**Sub-Committee of Experts on the Globally Harmonized
System of Classification and Labelling of Chemicals**

Thirty-first session

Labelling of small packagings: comments on document ST/SG/AC.10/C.4/2016/8

Transmitted by the expert from the United States of America

Metal container with 100 ml capacity

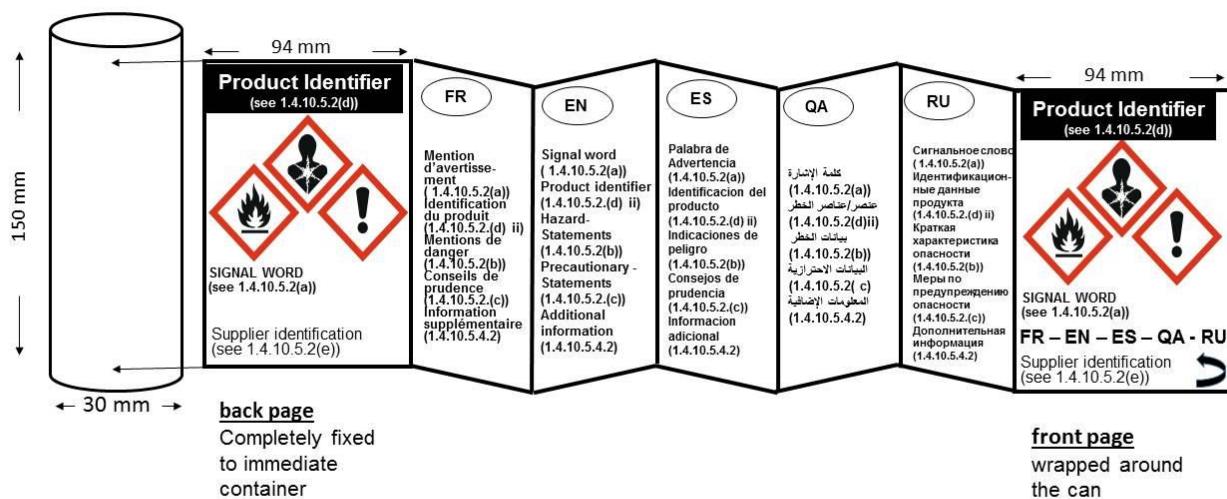
3. In addition, the United States believes it is not appropriate to include measurements for the containers and the label in the example. The size of the container in the example (150 mm high x 30 mm diameter) appears to have sufficient surface area to fit the GHS pictogram(s), signal word, and hazard statement(s) together, particularly if the information need appear in one language only or if there are few hazard statements assigned to the chemical. Notably, the size of the full size label in example 8 of Annex 7 is significantly smaller (65 mm x 65 mm) than the size of the label in the proposed example 9 (approx. 150 mm x 94 mm).

This example is for use on containers where the manufacturer/supplier or competent authority has determined there is insufficient space to place the GHS pictogram(s), signal word, and hazard statement(s) together, as provided in 1.4.10.5.4.1, on the surface of the container (front of the pull-out label). This might occur, for example, when the container is small, there are a large number of hazard statements assigned to the chemical, and the competent authority requires information to be displayed in multiple languages, so that the information may not be printed on the label in a size that is easily legible without the aid of any device other than corrective lenses.

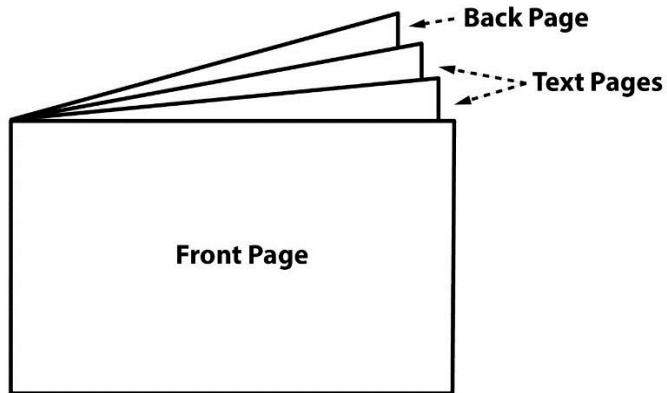
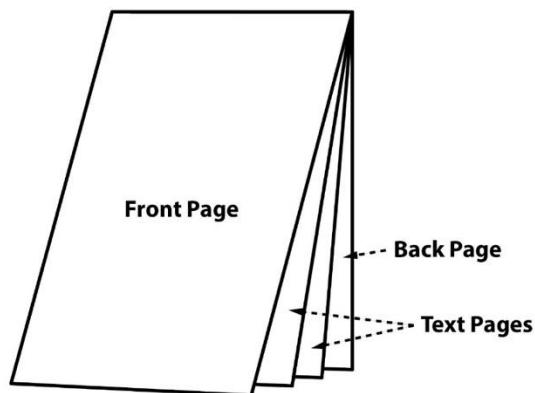
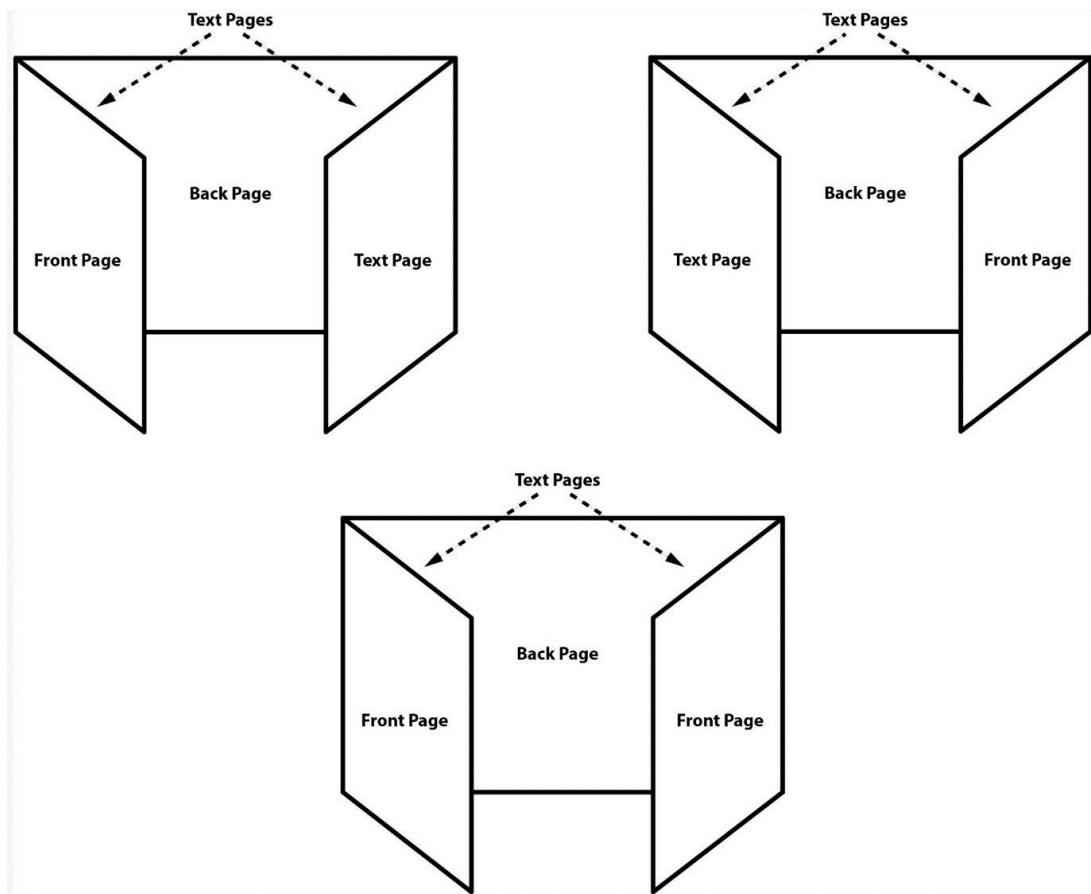
5. In addition, at the end of the proposed example, we suggest that additional text be included to clarify that the illustrations following the accordion style illustration show how the principles of the example apply to the book style, order book style, and window style foldout labels.

Additionally, the labeling principles discussed in this example could also be applied to the following foldout label styles: book style, order book style and window style.
